AHAM
association of home
appliance manufacturers

Date issued: April 4, 2007

Subject: Cavity Size

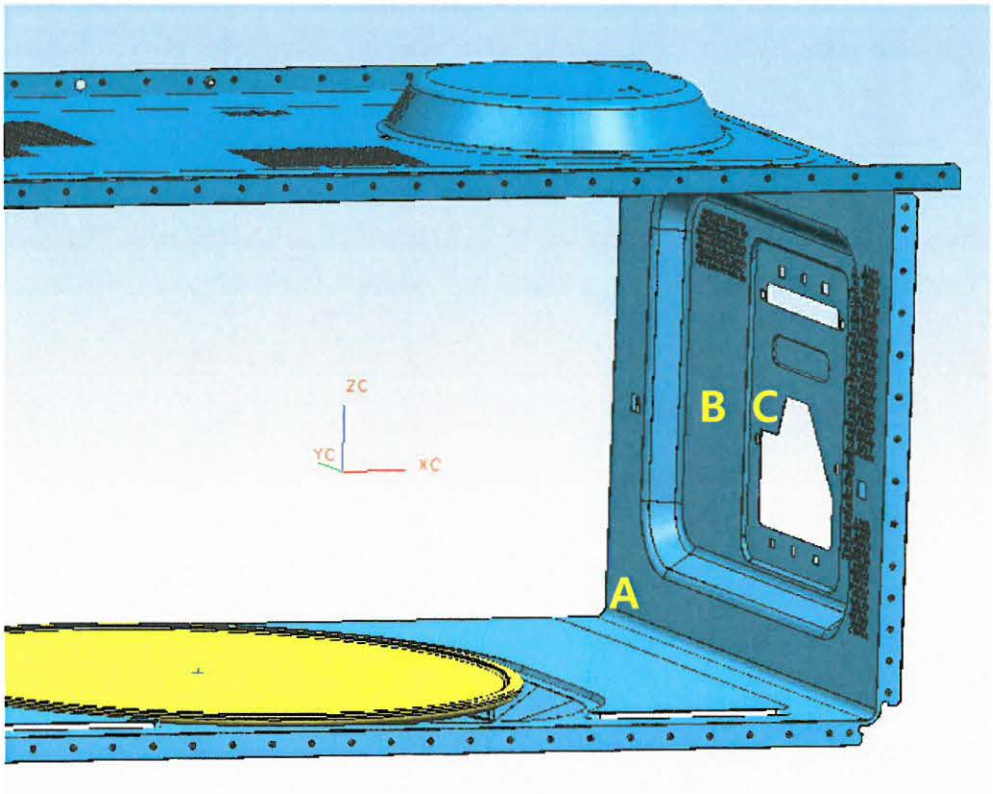
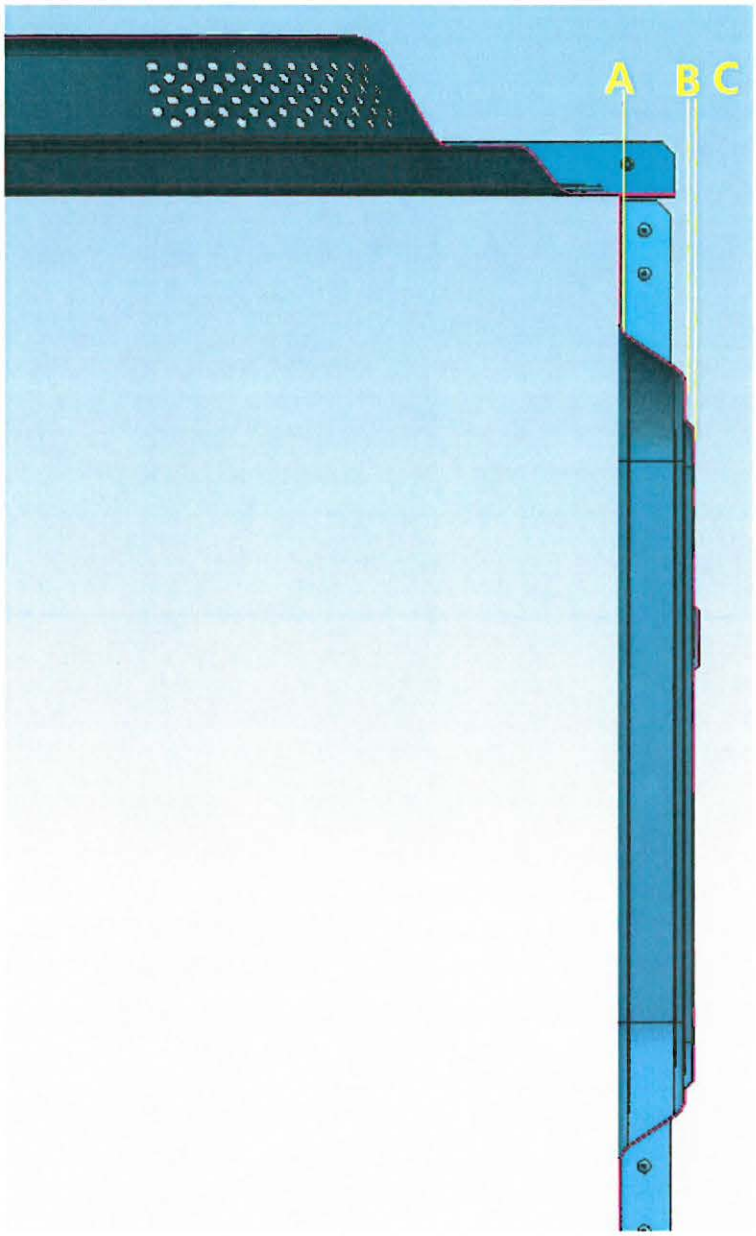
The plane B and C, in the figures below, has slight depth difference (almost 1 mm).
In case of define the largest surface regarding OV-1-2005, Cl. 4.1.2, B and C can be considered same plane?

ANSI/AHAM OV-1-2006 requires measurements to be made to the nearest 3 mm. Therefore it would be legitimate to regard B and C in your diagram as being the same plane.
